LINCOLN & DRANSFELDT

NORTHWEST 1/4 OF SECTION 15, TOWNSHIP 6 SOUTH, RANGE 66 WEST OF THE 6TH P.M. COUNTY OF DOUGLAS, STATE OF COLORADO

WATER AND SANITARY PLANS

LINCOLN & DRANSFELDT
 SANITARY PLAN & PROFILE

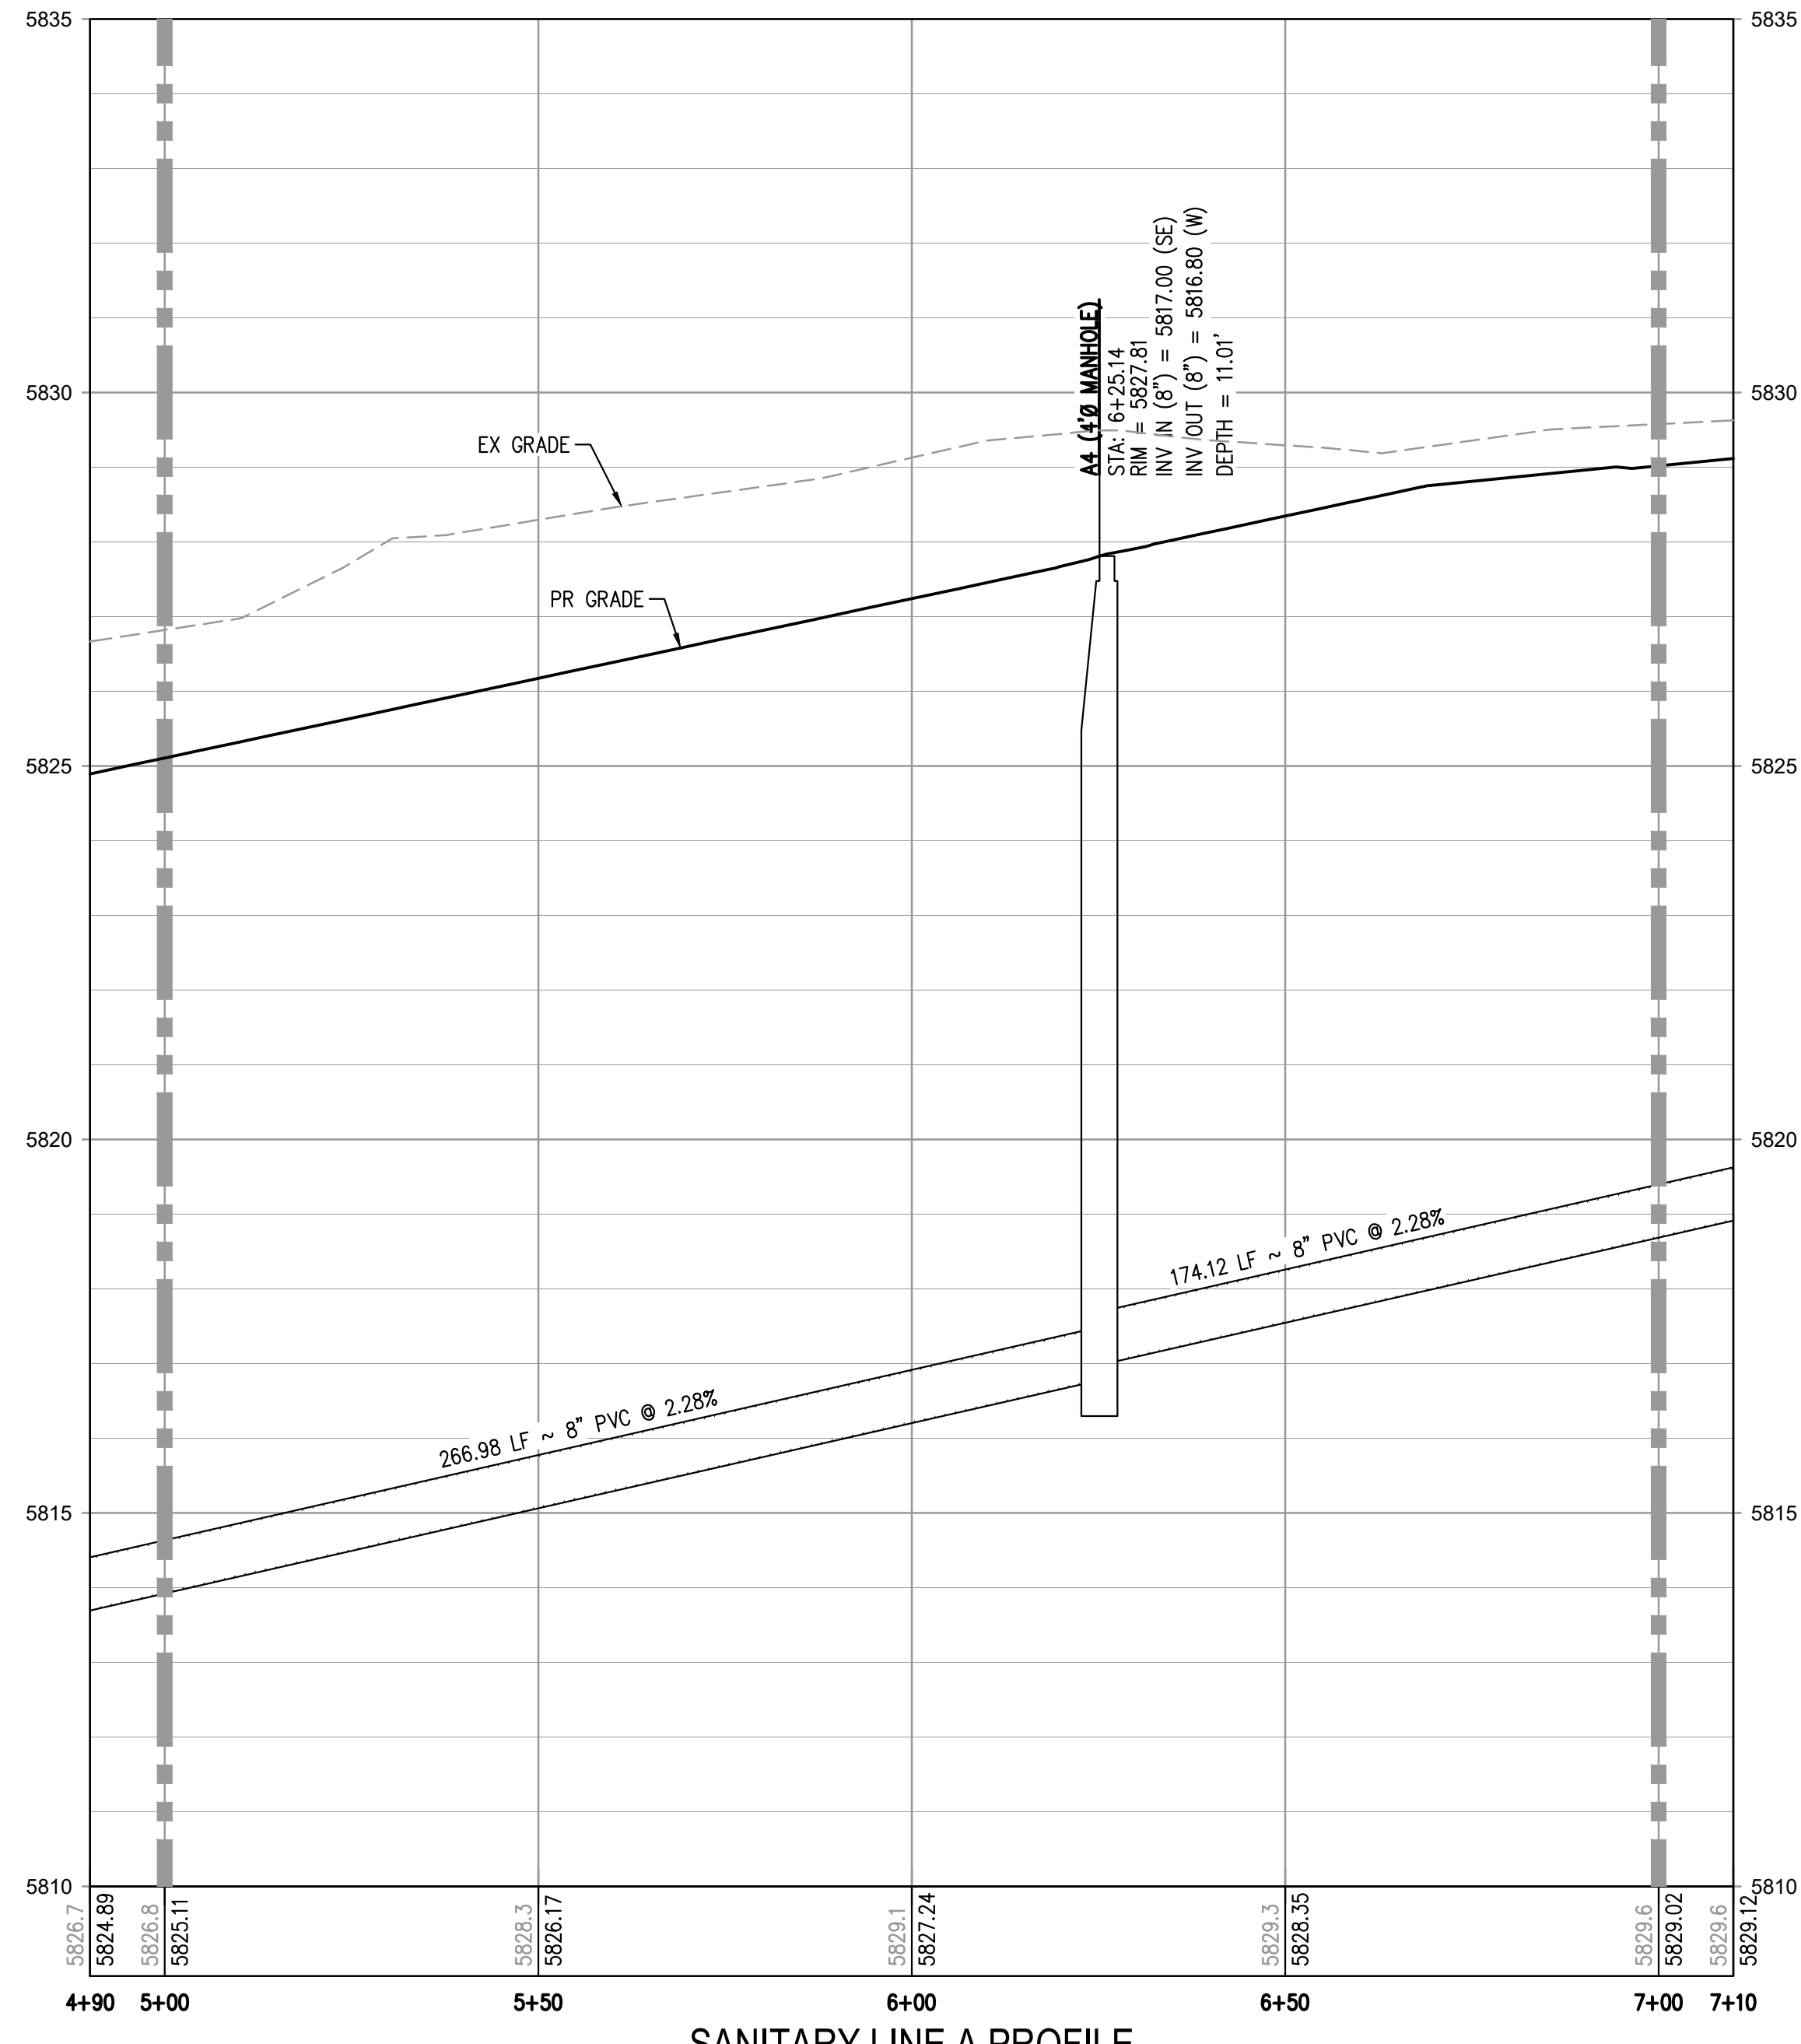
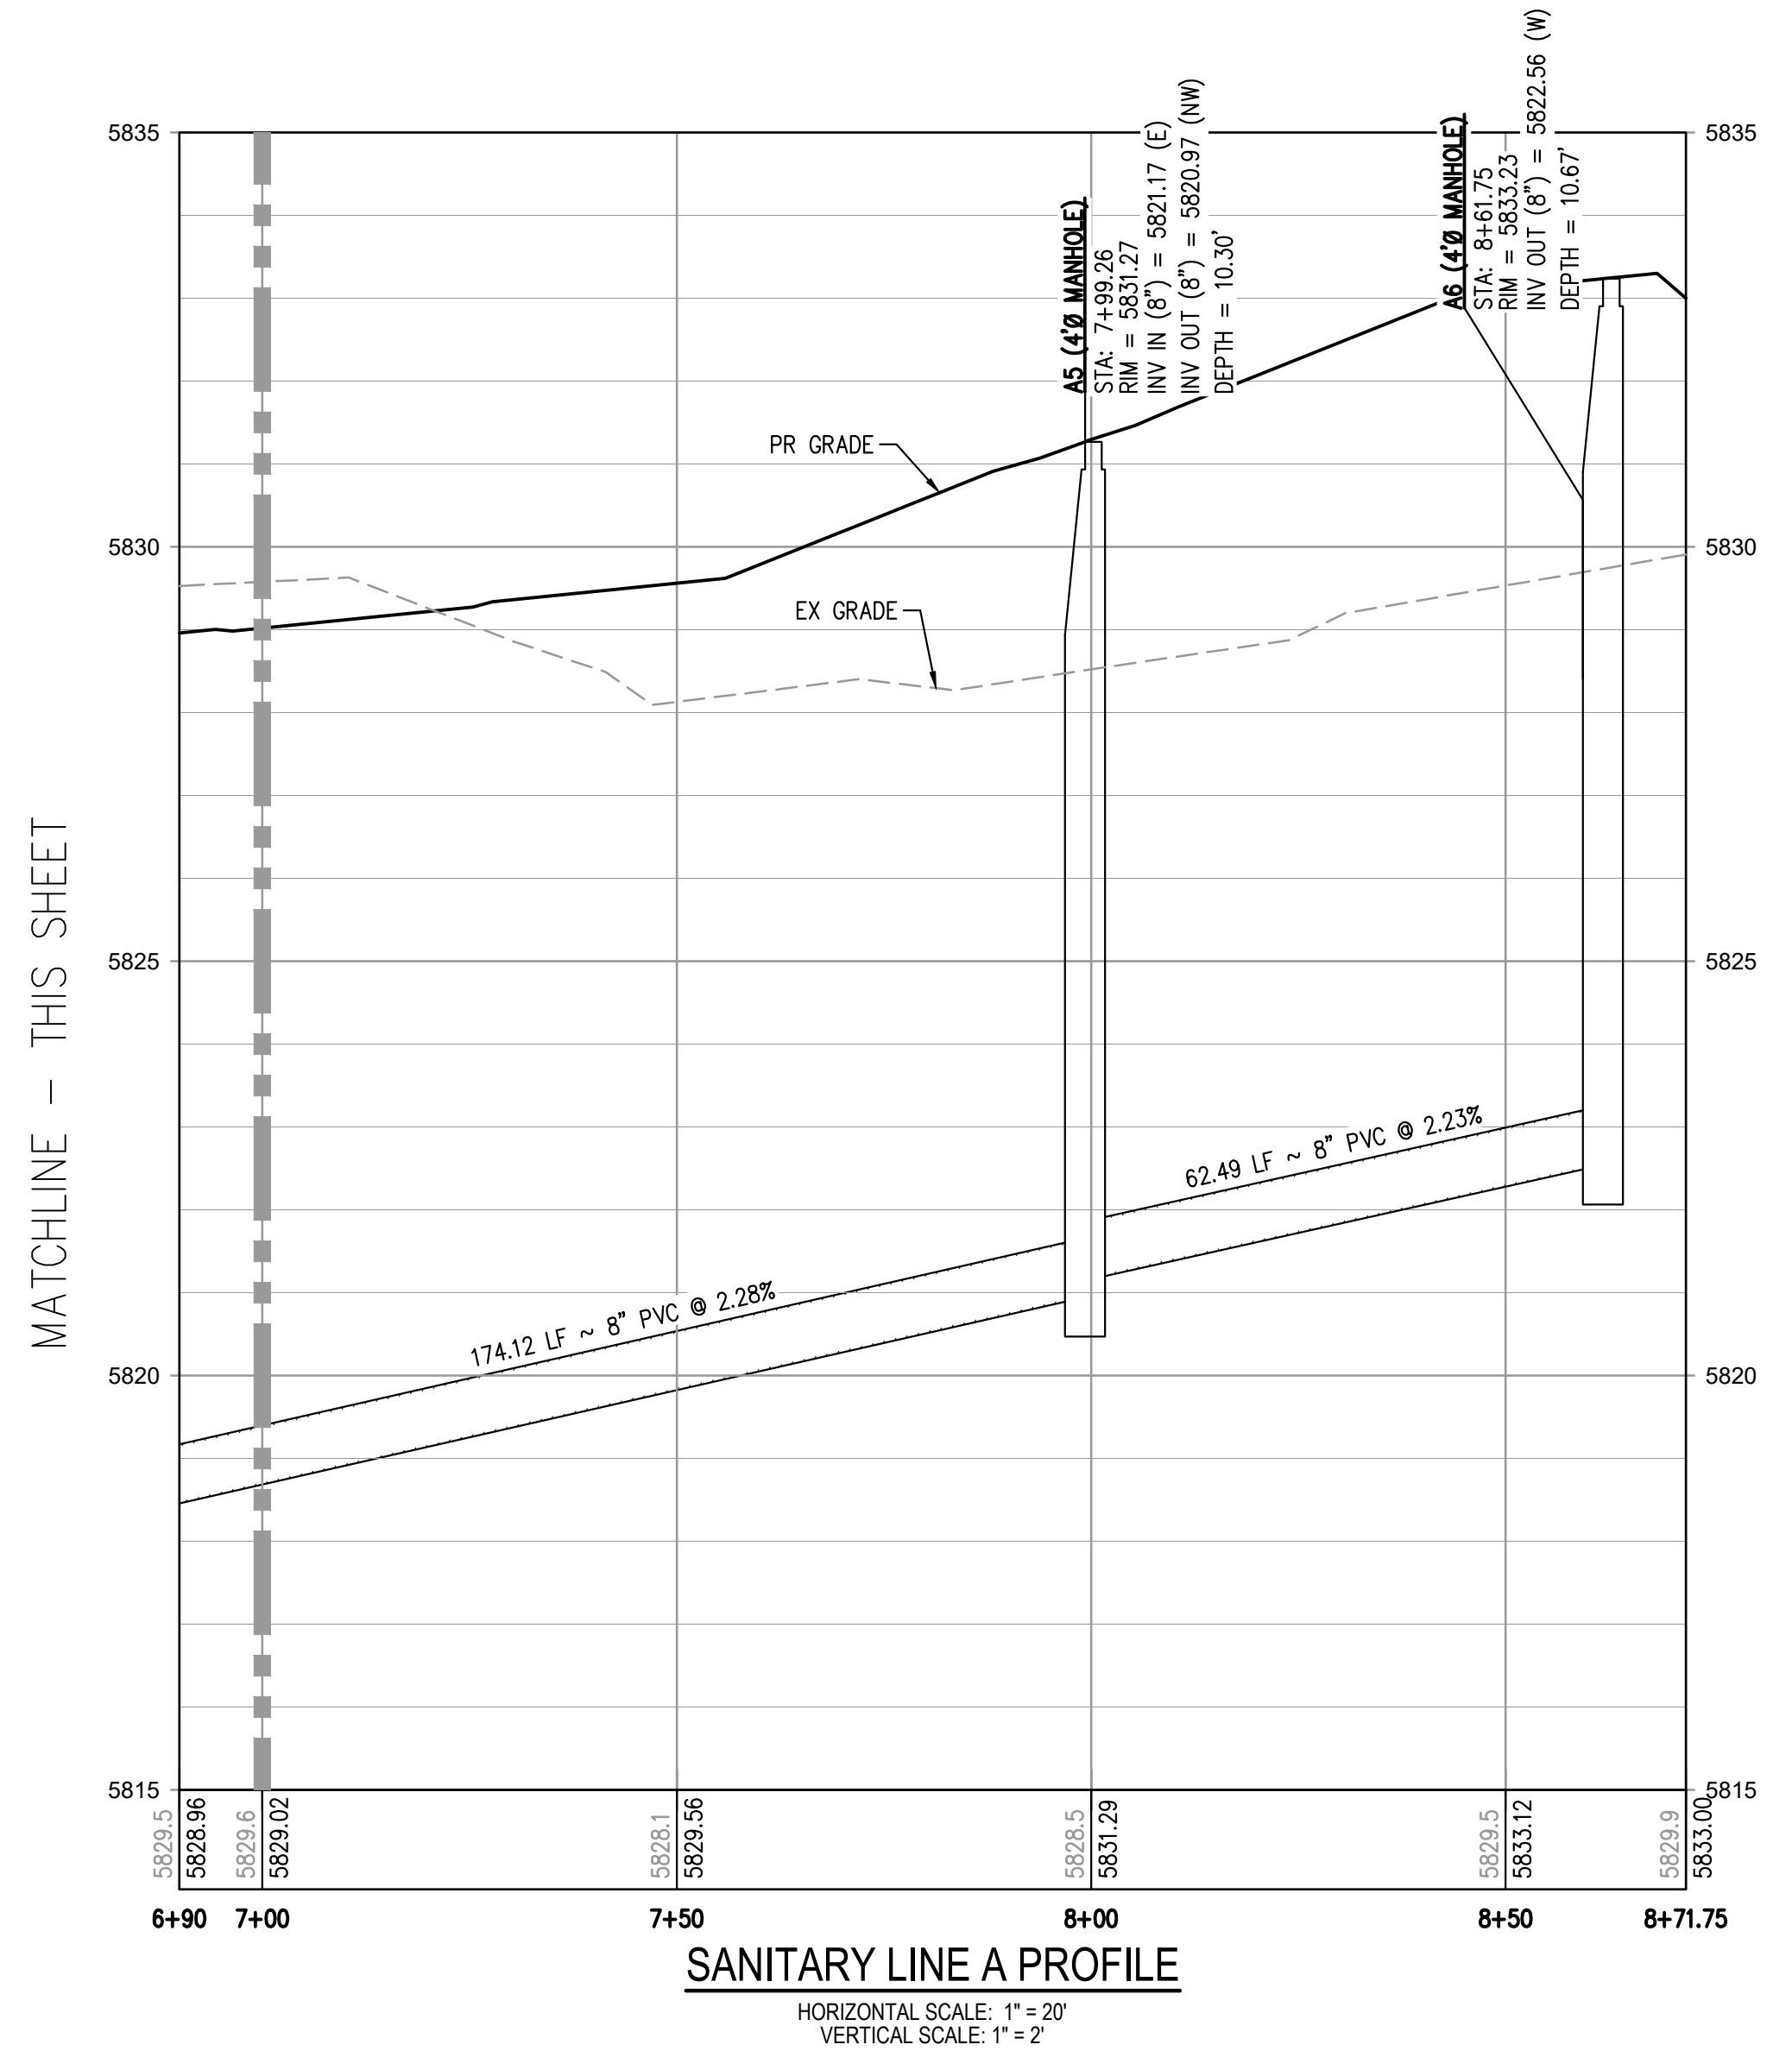
Call out All Crossings
